ADDENDUM NO. 1

PROJECT: Fort Owen State Park – East Barracks Preservation – Phase II

FWP PROJECT #: 7216207

DATE: March 29, 2023

SHEET: 5R of 7

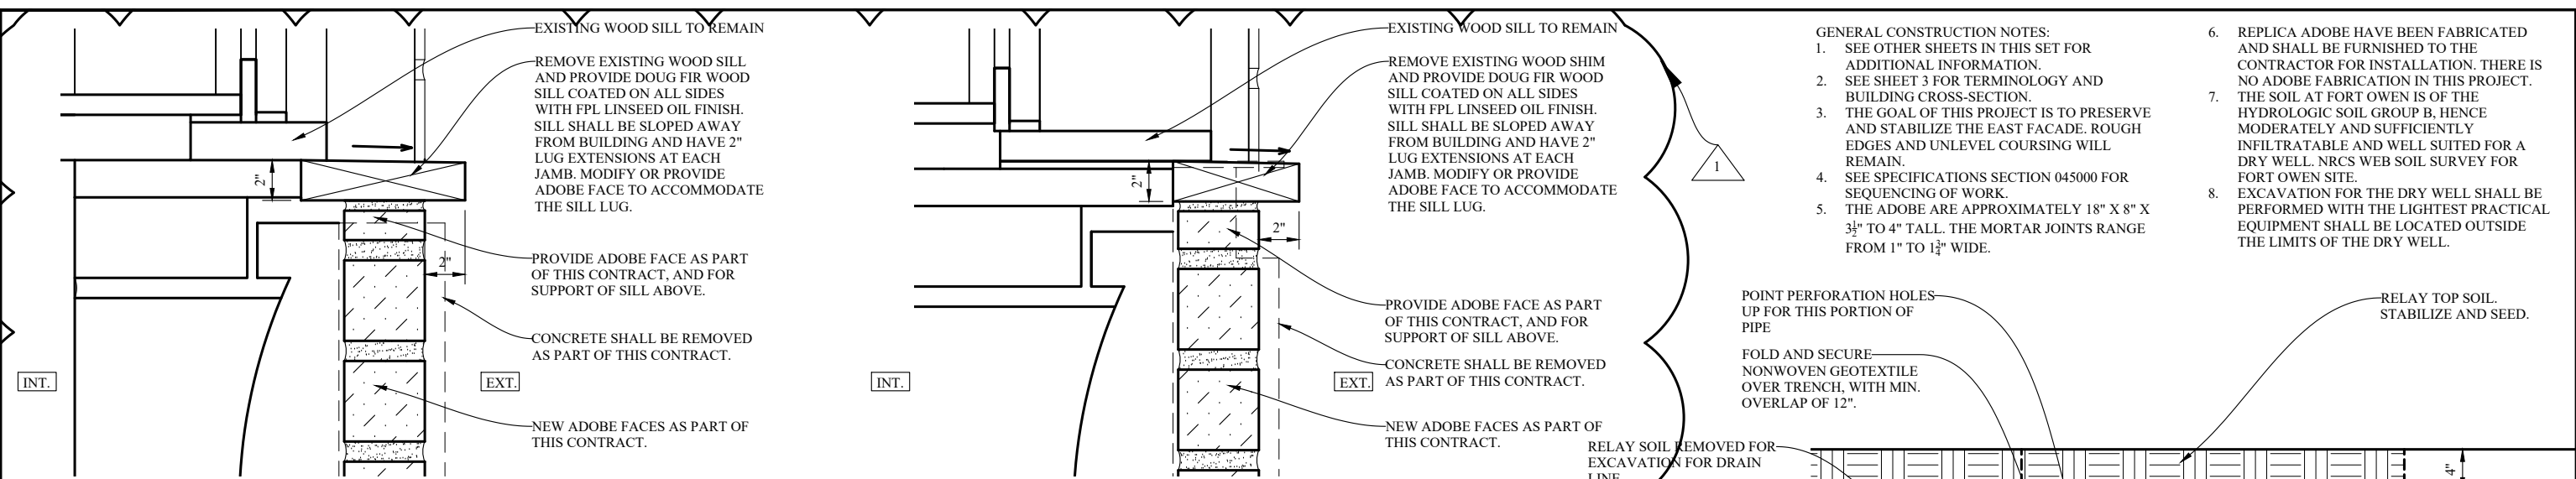
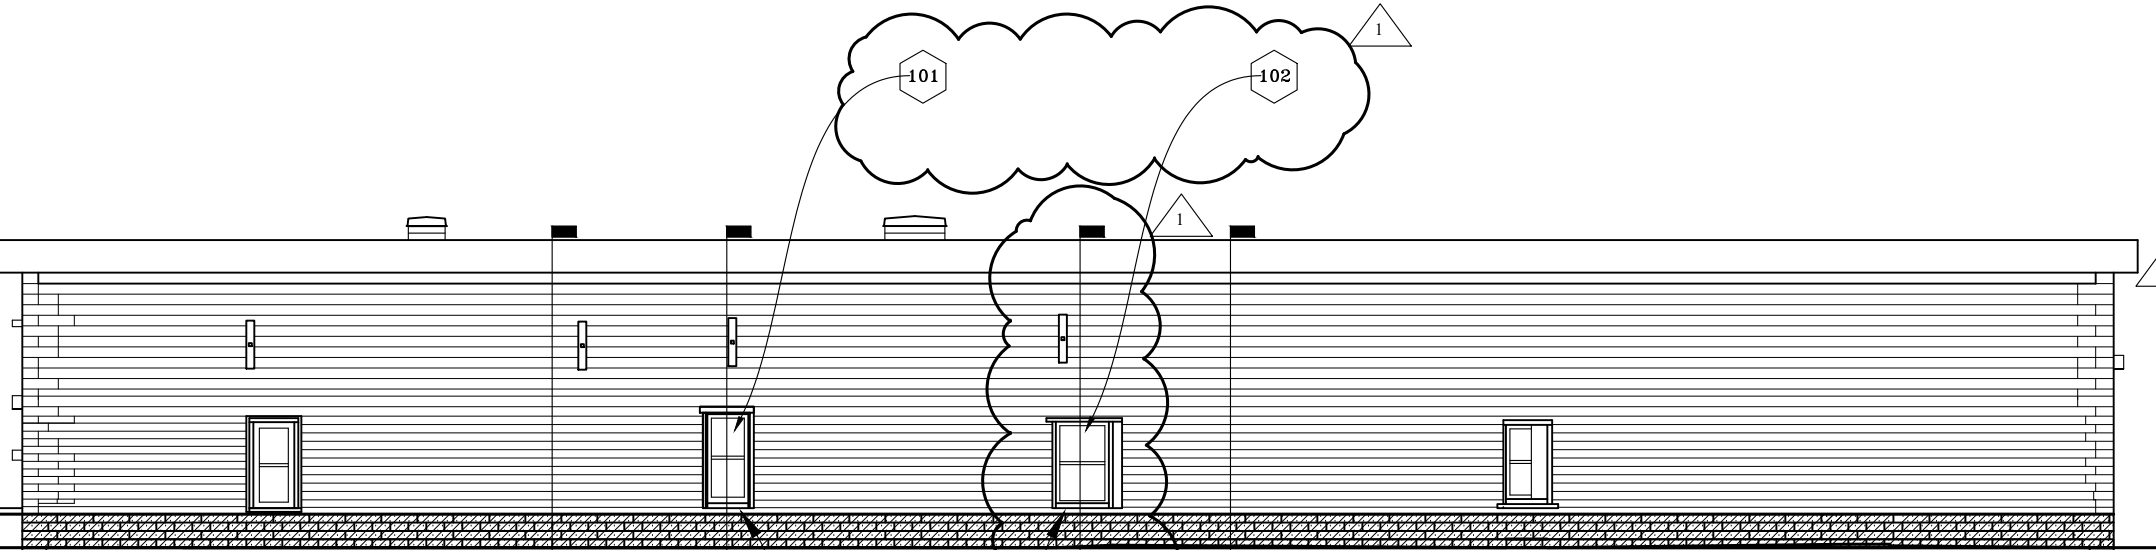
1. **Drawing Sheets:**
 - a. Replace Sheet 5 with the attached revised Sheet 5R, dated 3/30/2023.
 - b. Replace Sheet 7 with the attached revised Sheet 7R, dated 3/30/2023.

- ITEMIZED SELECTIVE DEMOLITION NOTES:
- D1. REMOVE CONCRETE APRON IN 4'-LONG SECTIONS, TO THICKNESS OF 5", DOWN TO GRADE. USE WOOD CRIBBING TO SUPPORT ADOBE WALL ABOVE. REVEAL THE ORIGINAL ADOBE, TAKING CARE TO RETAIN AS MUCH ADOBE AS POSSIBLE. UPON EXPOSURE, REMOVE ANY LOOSE AND CRUMBLING CONCRETE AND ADOBE. SEE SPECIFICATIONS FOR REMOVAL METHOD.

REMOVE 5" THICKNESS OF CONCRETE APRON, DOWN TO GRADE LEVEL.

- R1. INSTALL REPLICA ADOBE FACES, IN ORIGINAL COURSING AND BONDING PATTERNS, PER DETAILS ON SHEET 6.
- R2. REMOVE EXISTING WOOD SILL EXTENSION AND PROVIDE WOOD SILL EXTENSION PER DETAIL ON SHEET 7.
- R3. PROVIDE SLOPED FOUNDATION DRAIN PER DETAIL 2 SHEET 6.
- R4. DASHED LINE IS STONE FOOTING.
- R5. CAP END OF DRAIN PIPE.
- R6. DRAIN PIPE HEADS NORTHEAST AT THIS POINT. SEE PLAN 1 SHEET 2, PLAN 1 SHEET 4, AND DETAIL 3 SHEET 7.
